P.O.A.D.P. PLAN  
for  
INTERCHANGE PARK

Re: Interchange Park

POADP # 583

## P.O.A.D.P REVIEW

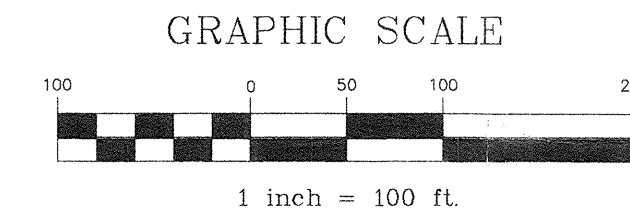
- Access and R.O.W. issues along State facilities will need to be resolved with the Texas Department of Transportation (TXDOT). For additional information about these requirements you can contact TXDOT at 615-5814.
- Based on the topography, a Flood Plain Study and drainage review will probably be required during the platting process.
- This development will need to comply with tree preservation ordinance #85262. For additional information about these requirements you can contact Building Inspections at 207-7102.

For residential development directly adjacent to State ROW, the developer shall be responsible for adequate set-back and/or sound abatement.

50' ROW flares will be required at the intersection of Fratt Road and US 81(Austin Highway). A 50' ROW flare will be required at the intersection of Interchange Parkway and IH 410.

The 16.654 acre tract is eligible for a maximum combined total of three(3) access points, and the 8.441 acre tract is eligible for a maximum combined total of two(2) access points. All access numbers are based on the overall combined US 81 frontage. Locations of access points will be as directed by "Regulations For Access Driveways to State Highways".

Permit applications along with plans for street, driveway, utility, sidewalk and drainage construction must be submitted to the Texas Department of Transportation for review and approval before working on highway ROW. TxDOT requires that a recorded plat accompany all driveway permit applications. The Owner/Developer is responsible for preventing any adverse impact to the existing drainage system within highway ROW.
